Sydney Central City Planning Panel - Council Assessment Report

Summary/ Application Details	
Panel Reference	PPSSCC-787
DA No:	DA/93/2023/E
LGA	City of Parramatta Council
Proposal:	Section 4.55(2) modification to approved mixed use development including replacement of commercial office floorspace in podium with 100 room hotel accommodation use, and revisions to basement layout, retail tenancy and apartment quantity/type/layout, façade design and landscaping.
Property	Lot 1 Sec 88 DP 758829, Lot 2 Sec 88 DP 758829, Lot 3 Sec 88 DP 758829 - Part of 34 Hassall Street PARRAMATTA NSW 2150
Date of receipt	9 October 2025
Applicant	Deicorp Projects (Hassall St) Pty Ltd
Owner	Deicorp Projects (Hassall St) Pty Ltd
Property owned by a Council employee or Councillor	No
Political donations/gifts disclosed	No
Regional Development Criteria	Pursuant to Clause 275(2) of the <i>Environmental Planning Regulations 2021</i> and Schedule 1 (3) of the <i>Instruction on Functions Exercisable by Council on Behalf of Sydney District or Regional Planning Panels—Applications to Modify Development Consents</i> - Departure of development standards. The modification proposes to depart from Clause 7.26(3)(b) of

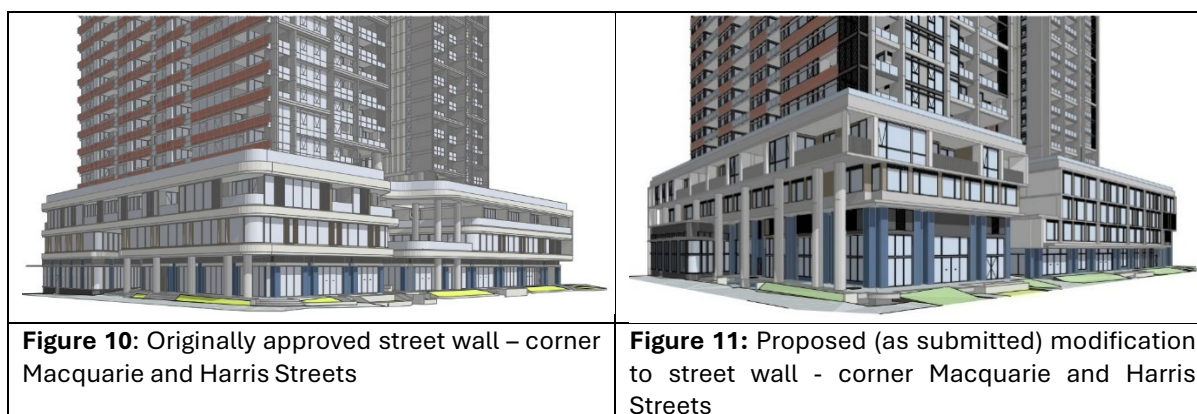
The initial submission resulted in significant design changes to the podium / street wall level due to:

- the introduction of a ‘fourth’ level along the western end of Macquarie Street frontage (to accommodate the hotel use); and
- the ground level floor height being raised at the corner of Macquarie and Harris Streets (to provide a partially for a double height retail space and part services).

Figures 10 and 11 provides a comparison of the street wall along these street frontages.

As originally submitted with the modification application (refer Figure 11), Council’s Design Excellence Team considered the design a regression in the design quality of the podium street wall as they have *“lost clarity and consistency, and present a disjointed resolution of their form and character”*. Council Officers requested a design revision to reinstate a consistent street wall treatment along Macquarie and Harris Streets, with a consistent corner form at their intersection, and a simple break in form on Macquarie Street for the arcade.

Turner Studio resubmitted the design to address Council’s feedback. **Figures 12 and 13** indicate the revised (current) proposal to the street wall along Harris and Macquarie Streets.

The revised scheme has responded to Council Officers comments in relation to street wall and retaining its significance as set out in the Parramatta DCP 2023 – Part 9 City Centre. The Design Excellence Team has concluded in relation to the revised scheme that they are “satisfied that the revised drawings acceptably respond to our previous comments and achieve design excellence as defined in the LEP.”
